From: [David A Dries](#)
To: [Pollock, Heather](#)
Cc: [Ted Bernstein](#)
Subject: Neighbor comments for 24-DDP-0055 at 5905 Fegenbush Lane
Date: Wednesday, April 2, 2025 11:37:00 AM

Related to the **updated proposed DDP filed 2-21-2025 for 24-DDP-0055**, I have the following updated comments and requests as a neighboring property owner at 7300 S Hurstbourne Pkwy . . . while being in overall support of Local 502's proposed development:

Strawman "Unified Access and Circulation" system

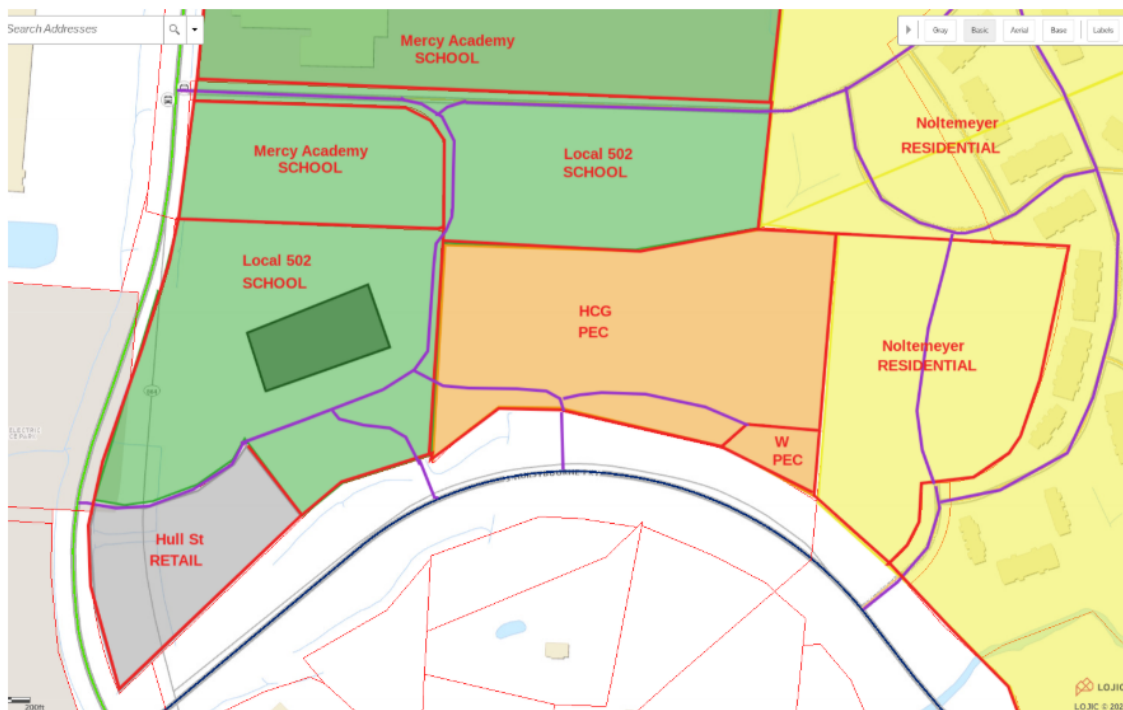
Related to a Unified Access and Circulation system (for 24-DDP-0055), below is a Strawman draft schematic for consideration by the Applicant and by the Planning Commission. This schematic appears better for all parties (including Mercy Academy) than the vague and confusing roadways in the proposed Development Plan. Edits and improvements to this Strawman schematic are welcome.

- **Details:** Proposed private roads (in purple) with defined access easements and crossover requirements.
- **Advantages:** Connects the major properties to Hurstbourne Pkwy and to Fegenbush Ln. Minimizes the non-school traffic and trucks crossing into the School and Residential areas. Consistent cross access and circulation agreements.

The proposed Roadway Connectivity (for 24-DDP-0055) needs to be up-to-date with the current planned uses for UA Local 502 and for Mercy Academy

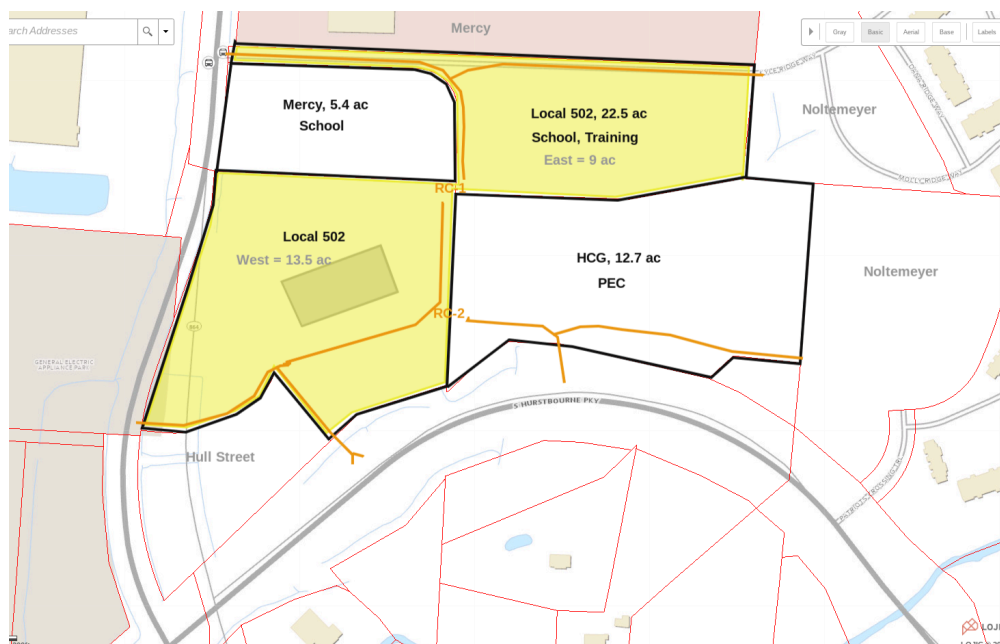
- Major changes in property configurations and property uses occurred recently with Mercy Academy adding 5.4 acres to its campus in Dec 2023, and Local 502 acquiring 22.5 acres in March 2024 for its new campus. Now in 2024, there are 3 different main properties: Local 502 = 22.5 acres; HCG = 12.7 acres; and Mercy Academy = 5.4 acres.

- Local 502 (22.5 acres, shaded in yellow below) is now the main (keystone) property in the area for roadway connectivity (instead of HCG's property). "Direct, short, and simple connections" (as described in the Comp Plan 2040 Mobility policies) should be required for a better-planned internal Access Road connecting Local 502's West and East parcels.

- As shown with the Orange roadway lines in the graphic below, there may be a general consensus on a good Access and Circulation system, **except for:**

- **How Roadway Connection #1 (RC-1) is best completed** . . . for the north-south Access Road connecting Local 502's West and East parcels. The proposed connectivity in the northeast portion of the 13.5-acre Site is awkward and confusing.

- **And how Roadway Connection #2 (RC-2) is best completed** . . . for a possible stub connection to the Hurstbourne Pkwy frontage Access Road.

Connectivity schematic roughly illustrating the new Development Plan (dated 11-26-2024)

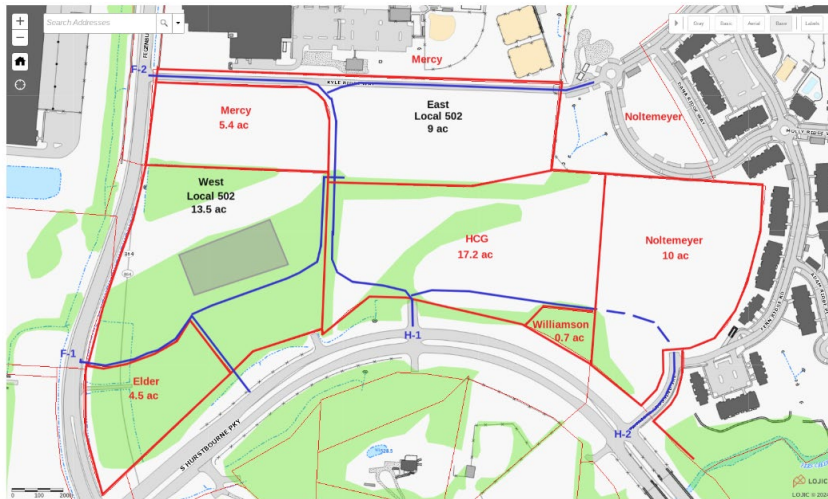
- As a neighboring property owner, from my view (as roughly illustrated by the LOJIC schematic below) the Access Drive on the new proposed Development Plan (11-26-2024) appears to be a significant improvement for roadway connectivity serving the Applicant's two parcels.
- However, the proposed roadway alignment in the northeast portion of the 13.5-acre Site still appears to be awkward and confusing.
- It also appears that some additional pavement edges are needed to define the Access Drive across the 13.5-acre Site, to help separate the connecting roadway from the truck loading and parking areas. And 24-DDP-0055 should clearly provide crossover rights for the adjacent properties.

My proposed connectivity schematic (as a better option to consider)

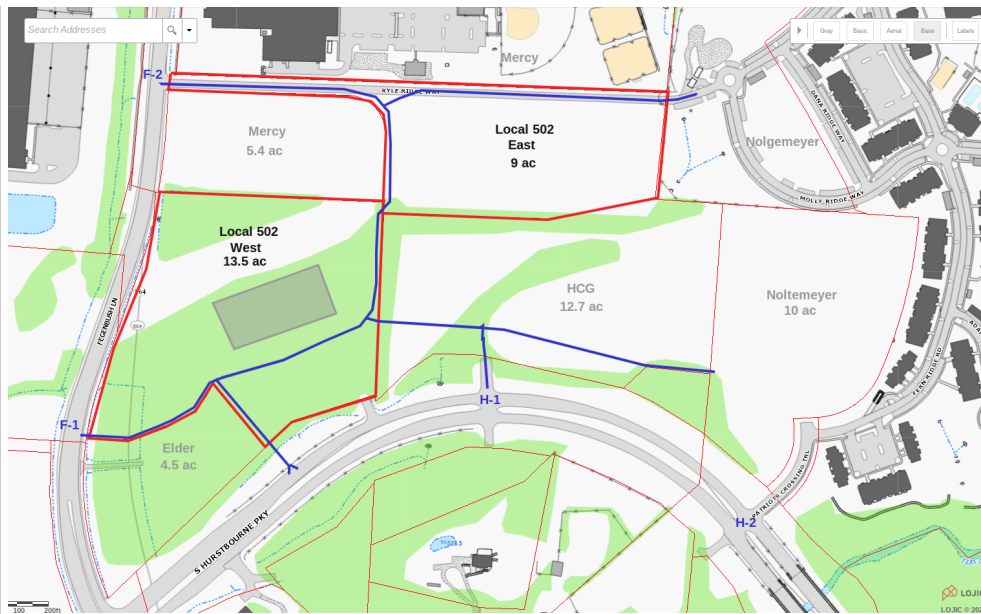
Contrary to the vague General Note #16 on the proposed Development Plan, **a Unified Access and Circulation plan should be prepared now (with 24-DDP-0055), instead of later. And the Unified Access and Circulation system should cover the Applicant's entire 22.5-acre property.** Section 1.6 (Appendix 6A) of the Land Development Code (LDC) states that "integrated development sites comprised of more than one building or more than one lot are not considered separate properties in relation to the access management standards of this code."

A well-planned Unified Access and Circulation system would only require a minimum amount of communication and cooperation among the few neighboring parties and Louisville Metro. Although the Unified Access and Circulation schematic (as illustrated below) may not be the best option, it appears to be a much better Access and Circulation system than the proposed Development Plan. This type of connectivity option provides "direct, short, and simple connections" (as described in the Comp Plan 2040 Mobility policies), which are beneficial for the area and which minimize the probability of a high-speed, cut-thru roadway across these properties.

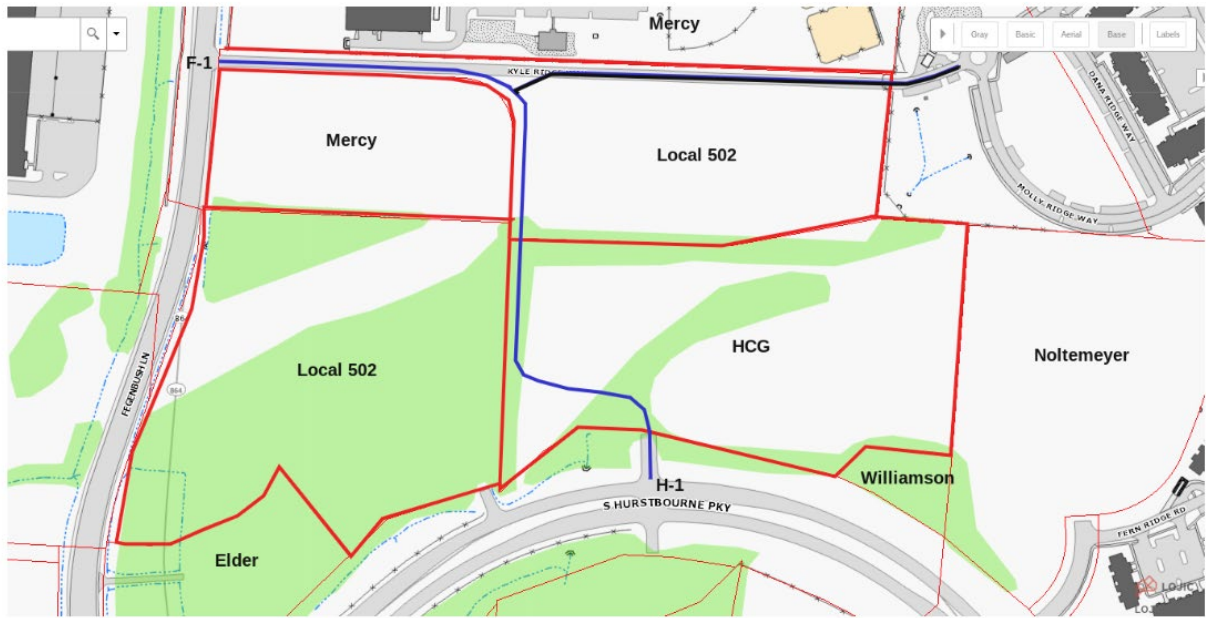
Also for Louisville Metro's consideration, now that the proposed uses are better defined for the area (see LOJIC drawing below) and since all of the properties have excellent existing access to Hurstbourne Pkwy and/or Fegenbush Lane:

- Maybe fewer crossover connections would be less confusing and more advantageous for all.
- For example, since Mercy Academy's new 5.4-acre property (located south of Kyle Ridge Way) is split from the original Mercy campus by Kyle Ridge Way, Mercy Academy may prefer fewer PEC and other properties connected to Kyle Ridge Way . . . in order to avoid a cut-thru shortcut between Hurstbourne Pkwy and Fegenbush Lane.
